V2500-A5/D5 PROPULSION SYSTEMS SERVICE BULLETIN

V2500-ENG-72-0328
Transmittal - Page 1 of 2

ENGINE – HIGH PRESSURE TURBINE ROTOR AND STATOR ASSEMBLY – INTRODUCE A NEW STAGE 2
HIGH PRESSURE TURBINE BLADE RETAINING PLATE

Location of the Stage 2 High Pressure Turbine Blade Retaining Plate
Figure 1

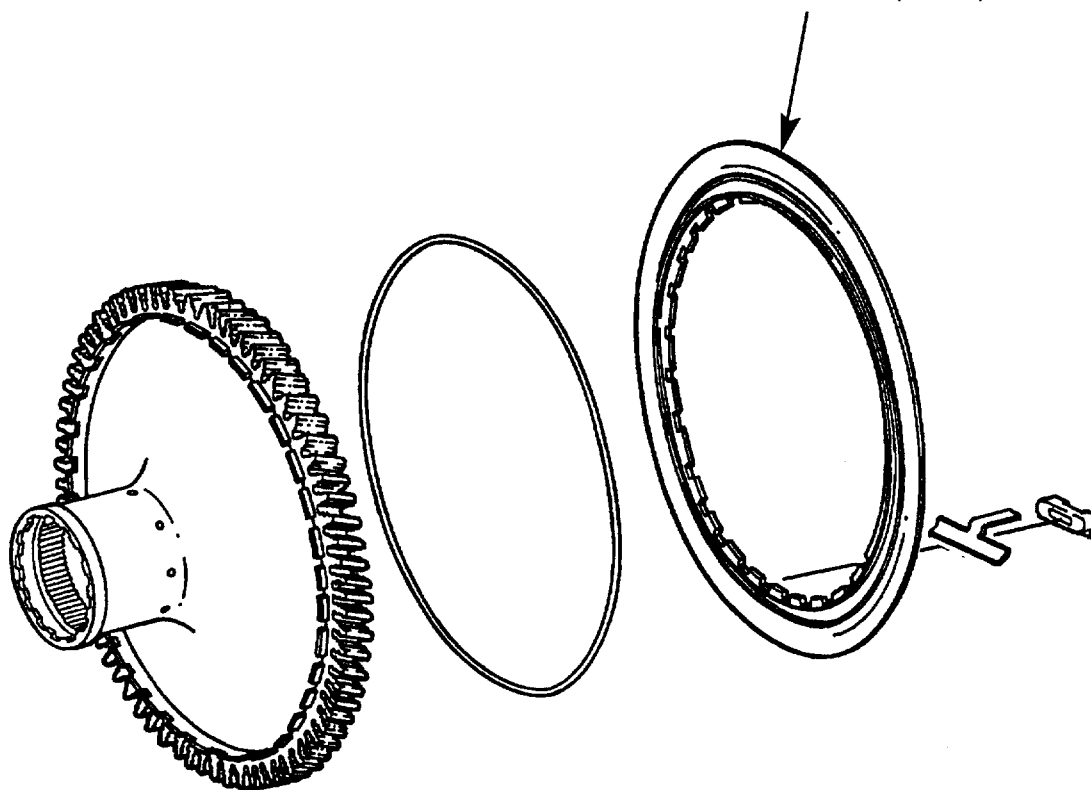
- (1) Install the 2A3437 Stage 2 HPT Retaining Plate (1 off) by the procedure specified in Reference (3) or (4), Engine Manual, Chapter/Section 72-45-30, Assembly. See Figure 1.
- (2) Recording Instructions
 - (a) A record of accomplishment is required.

INSTALL THE 2A3437 STAGE 2
HIGH PRESSURE TURBINE BLADE
RETAINING PLATE (1 OFF)

Family Tree – Stage 2 High Pressure Turbine Sideplate Ref. Catalog Sequence No.
72-45-33. Fig. 01 Item 020
Figure 2

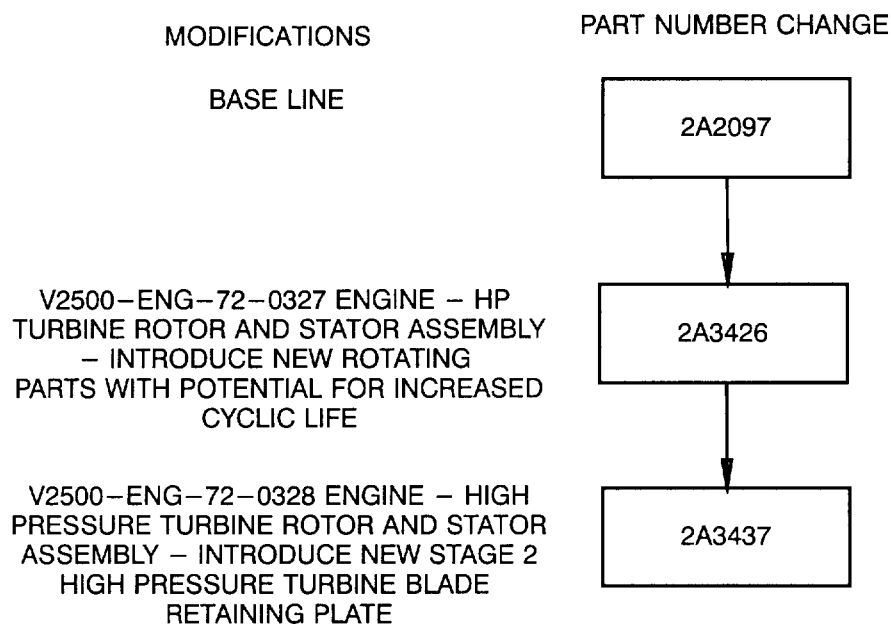
R Parts progression to show the changed part in relation to other parts
